Re: Supplemental Submission

Applicants' Response to Horsley Witten Peer Review Comment Letter dated November 23, 2020
Sudbury-Hudson Transmission Reliability and Mass Central Rail Trail Project

Figure 2. Picture taken at approximately 703+50 facing southwesterly.

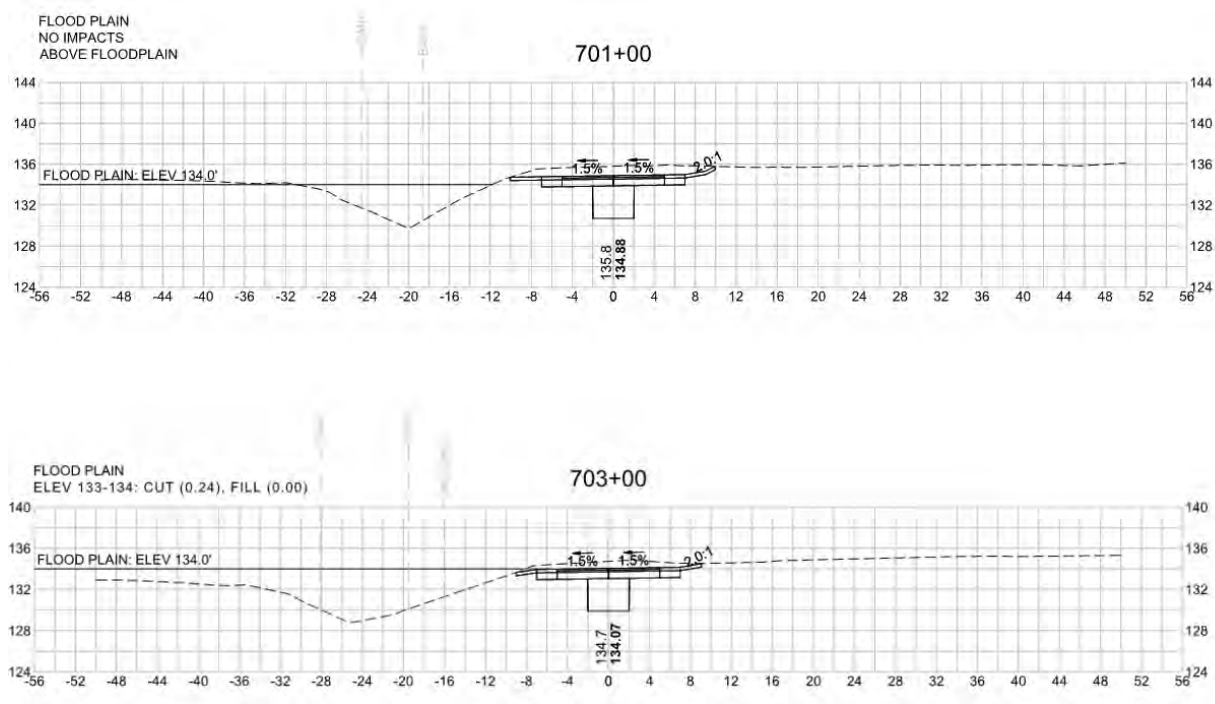
Within this portion of watershed 9.1, there is limited area between the proposed bike path and the existing development (Sudbury Lumber) to implement structural stormwater controls. This narrow area can be seen in Figure 1 below which was taken standing at approximately STA 700+00. Figure 2 shows another example of the limited space between the existing railbed and fencing at approximately STA 703+50.

Figure 4. Low point where water is collected from Sudbury Lumber at approximately STA 701+00, facing northerly.

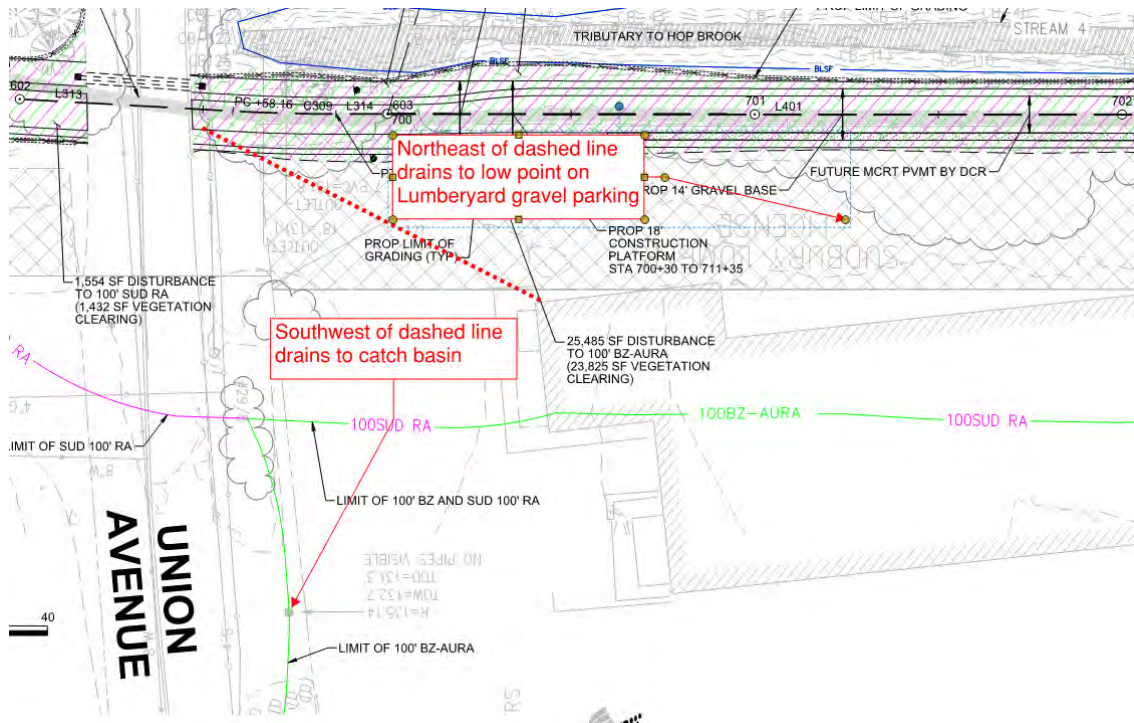
Concerning the potential for run-on from the lumberyard to the proposed bike path, the field visit confirmed that water from the abutting property either discharges to a catch basin in the parking lot or collects at a low point within a gravel portion of the lumberyard property. A picture of the low point as well as a marked-up plan view of this area can be seen in Figures 4 and 5 respectively.

Figure 8. Cross section view of existing depression on southern side of proposed bike path and STA 707+00.

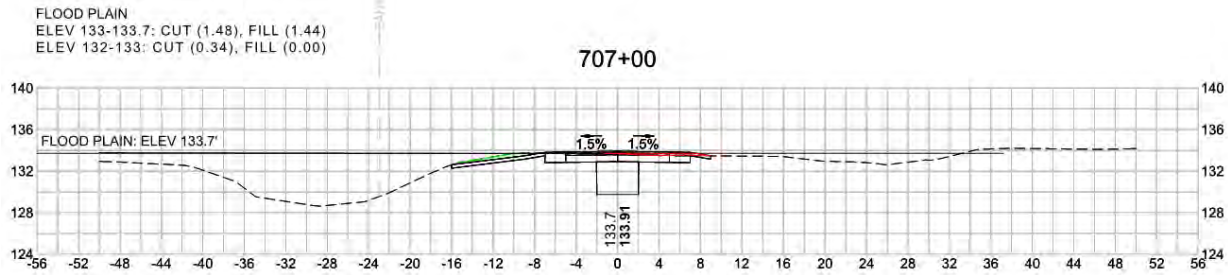
In addition to the benefits of impervious disconnection, a natural depression exists within this length of watershed 9.1 from STA 706+75 to 707+00 that serves to detain and treat stormwater. Figure 8 highlights this depression in a cross section view.

Figure 9. Bike path cross sections demonstrating topographic constraints to changing pitch of bike path in the area of STA 709+75 to 711+60. Changing the pitch of the bike path would require cutting and land disturbance to the south of the bike path, increasing resource area impacts.

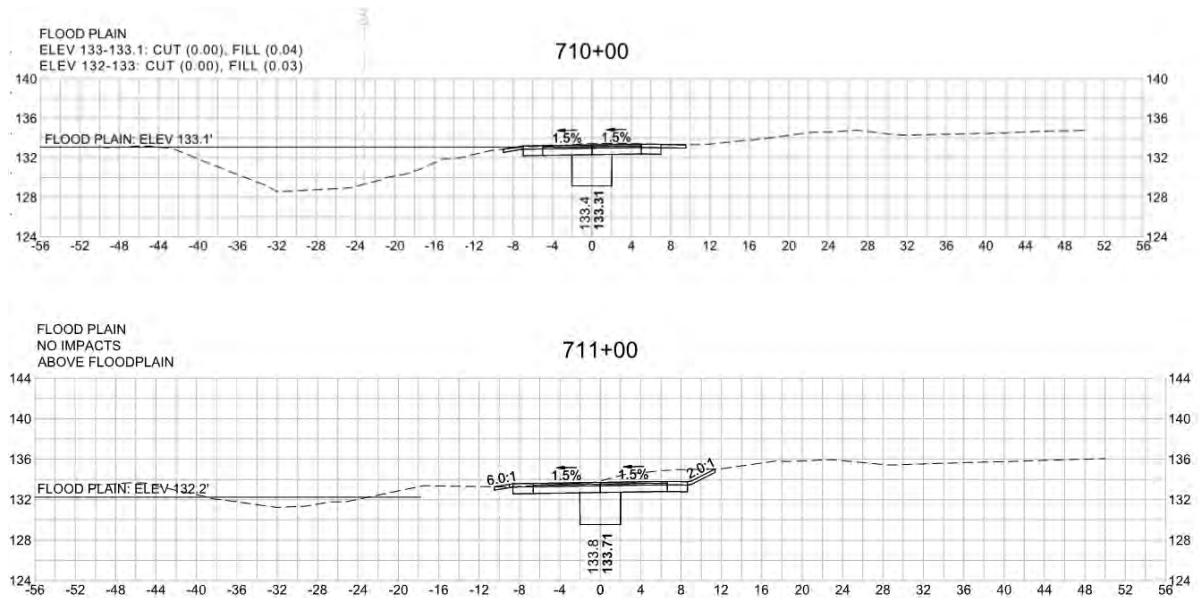
The portion of the proposed bike path between STA 709+75 and 711+60 was not crowned to avoid additional riverfront area and buffer zone impacts. These impacts are dictated by existing topographic constraints and the proximity of the abutting property. Examples of the topographic constraints described can be seen in cross section view (Figure 9) and pictures (Figure 10) below.
